Greater Cambridge City Deal
MILTON ROAD
LLF PROJECT UPDATE

9th May 2017

Do Optimum: Section 1

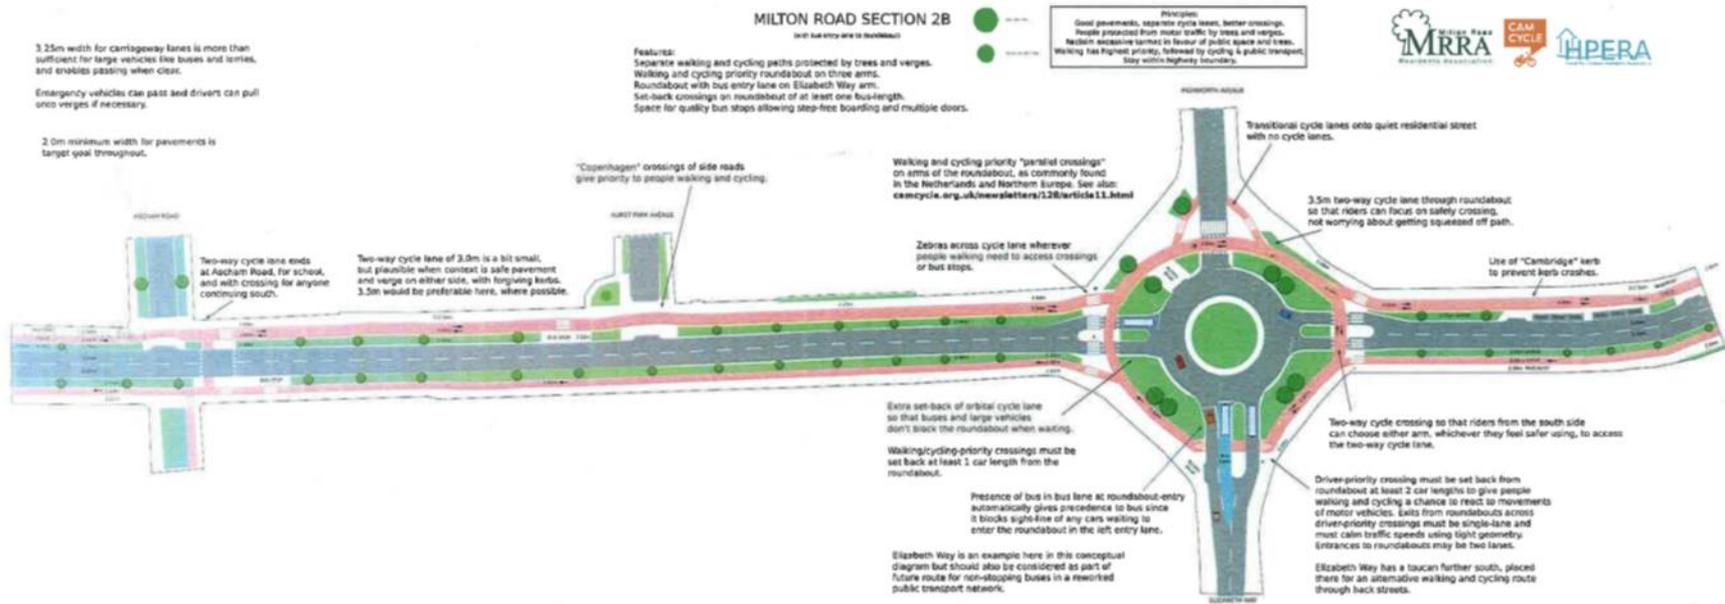
No priority for buses on Gilbert Road junction approach

Insufficient width available to accommodate current design and any bus lane

Is there a need for crossing at Herbert Street?

Do Optimum: Section 2

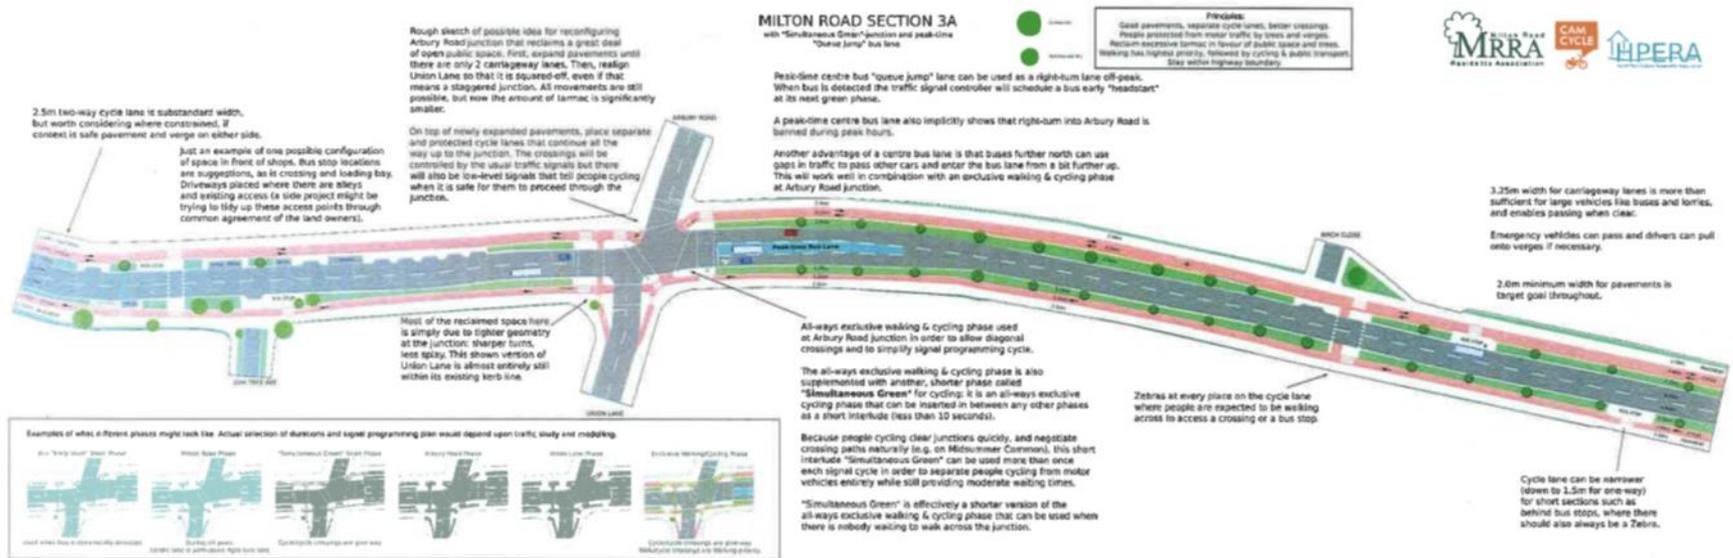
Does the Dutch style roundabout at Elizabeth Way provide sufficient capacity to manage queues?

Are bus lanes required on the Milton Road approaches to the roundabout?

Would a signalised T junction or cross roads work better?

Option of a signalised roundabout also being assessed

Do Optimum: Section 5

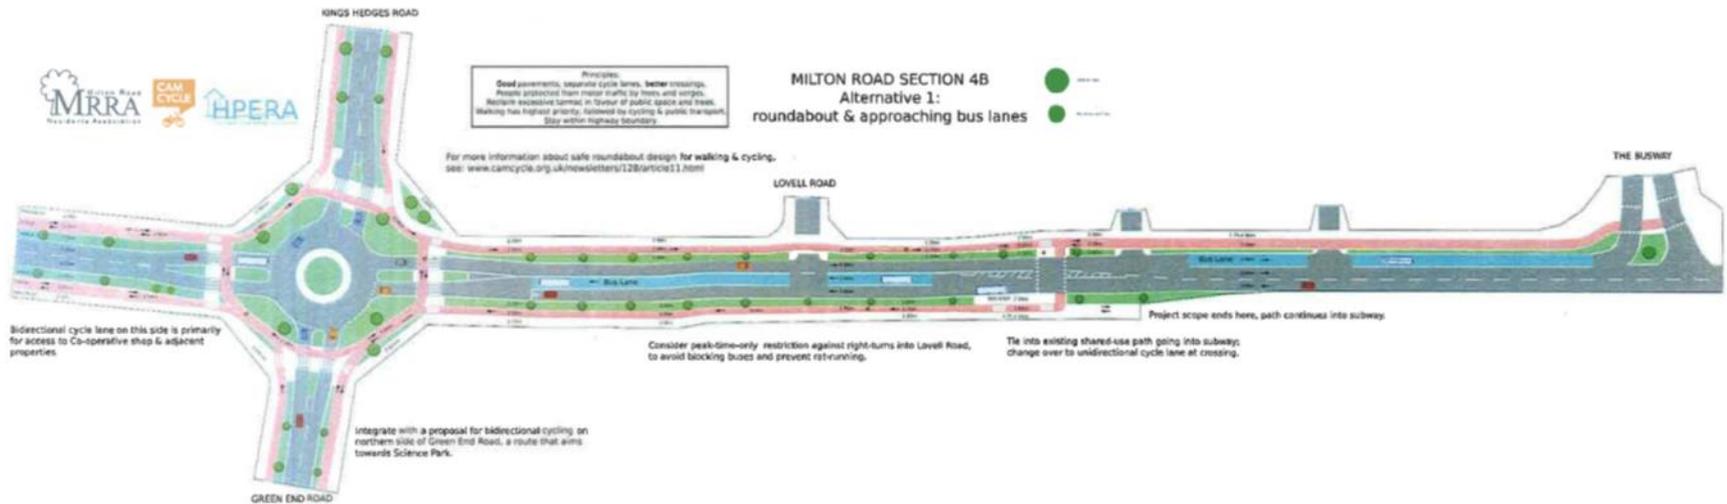
Anticipated queues likely to require space for bus lanes.
Is there sufficient room for bus lane and two-way cycling facility?

Number and location of trees will be constrained by private accesses.
